TGn Sync Response to Questions

Date: **2005-03-16**

Benefits of TGn Sync Extended MCS set (from presentation)

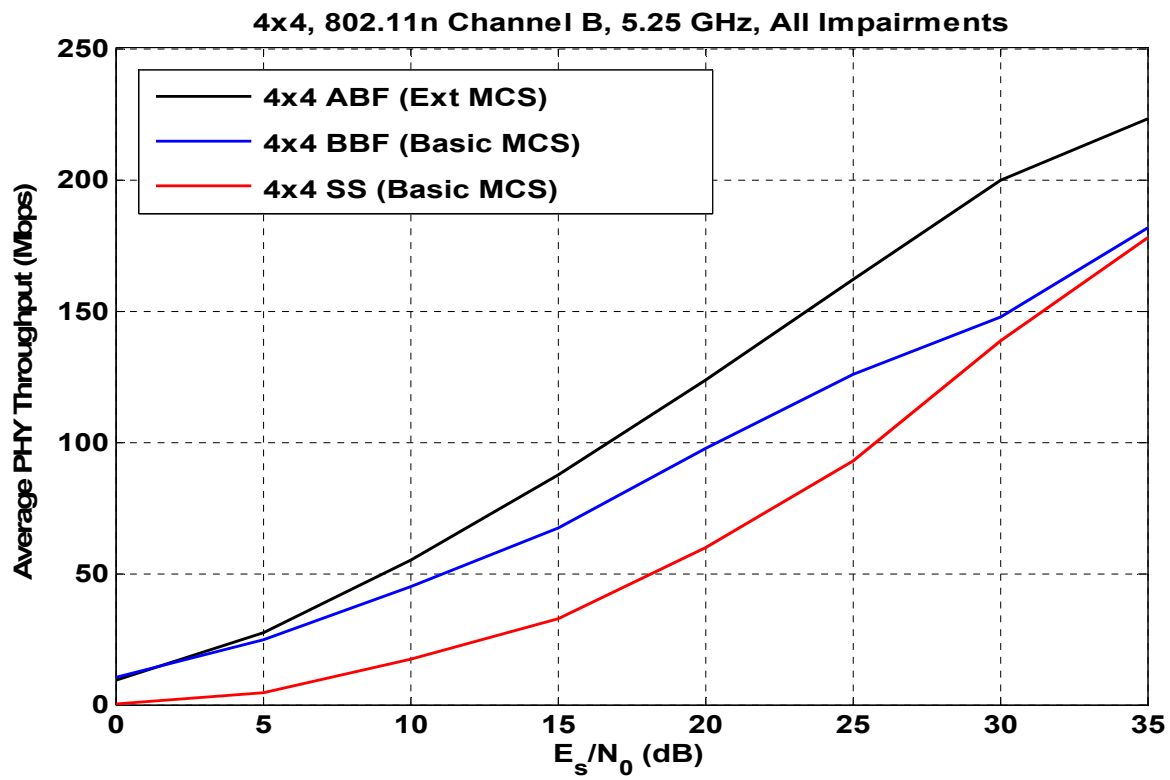
WWiSE – Q3

In ABF, instead of having, for example, {256-QAM, 256-QAM, 256-QAM, QPSK}, why not just use 3 spatial streams if the streams are that different in quality?

Tx BF is superior to STBC

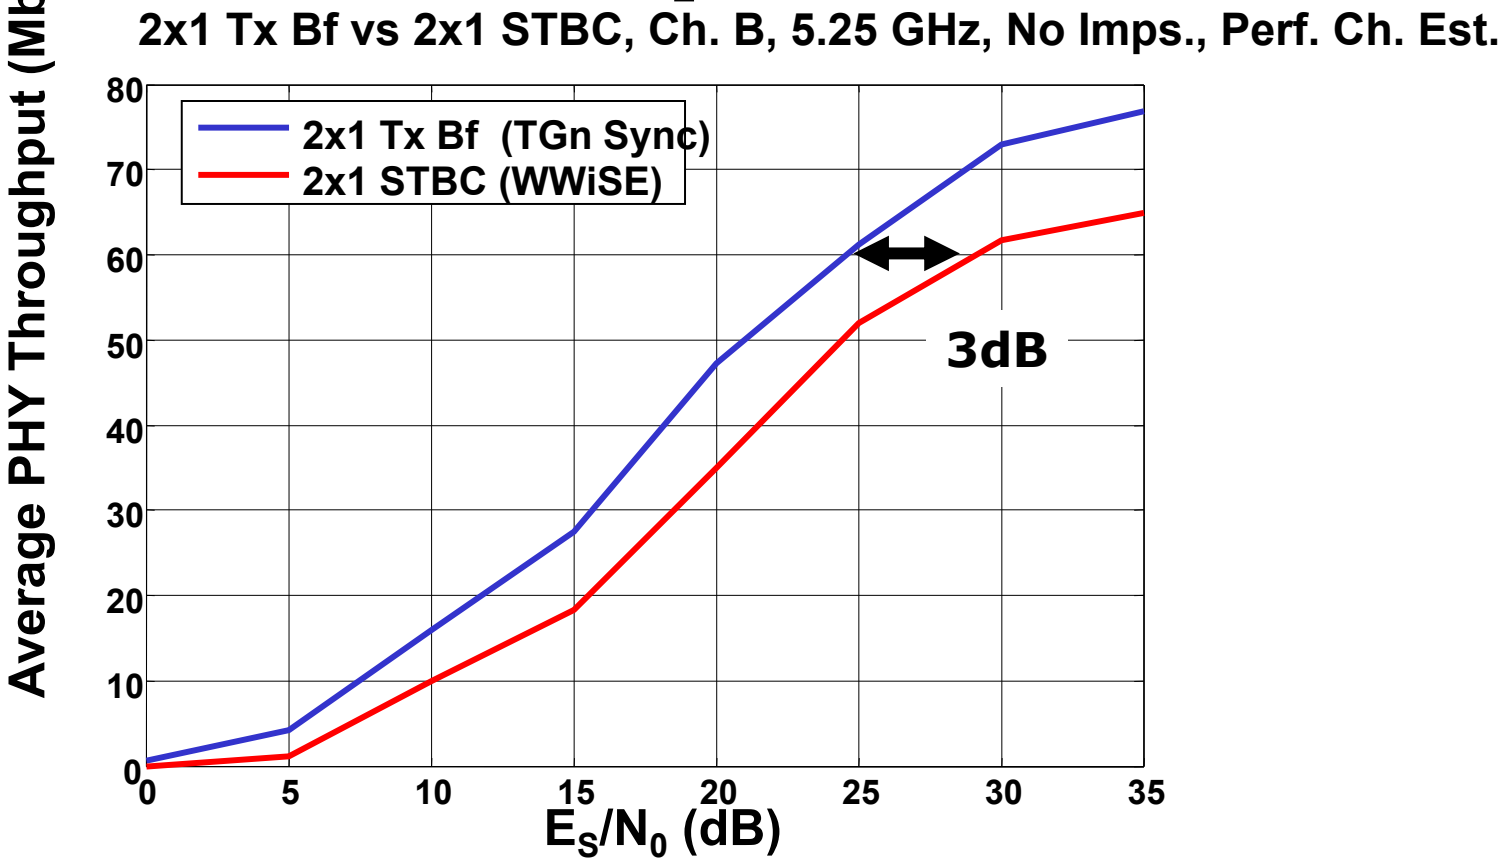
WWiSE – Q9

Why are space-time block codes missing from the proposal?

- Is there any technical reason why these have been omitted?

- Simplicity, not needed since TxBf outperforms it. Additional complexity of 2-symbol processing, overhead ofextra dead symbol etc.

➡ Also complexity of dual symbol processing, more modes etc.
